SUNDRY NOTICES AND REPORTS ON WELLS

2. NAME OF OPERATOR
Merrion Oil & Gas Corporation

8. FARM OR LEASE NAME
Canyon Largo Unit

9. WELL NO.
302

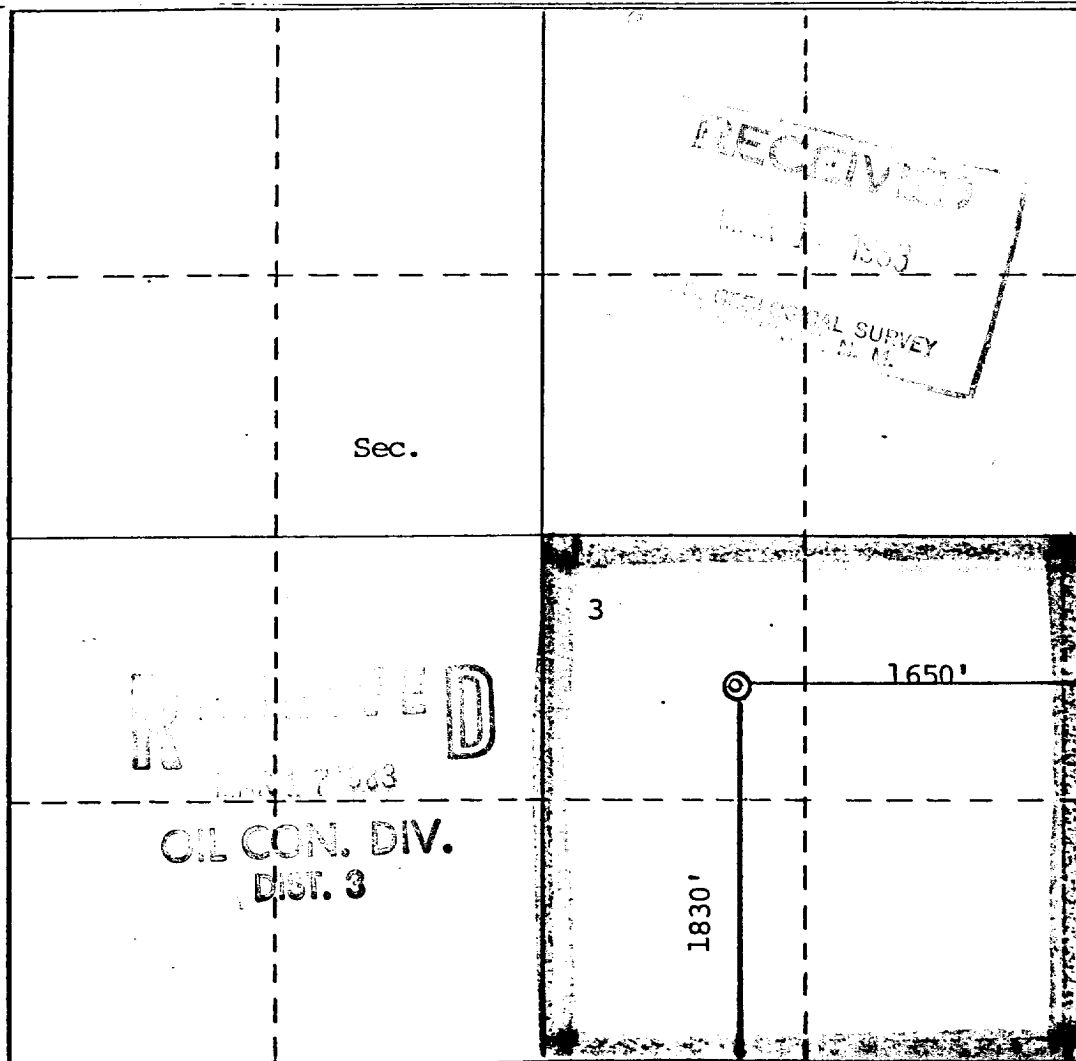
Plat showing 160 designated acres instead of 80 dedicated acres.
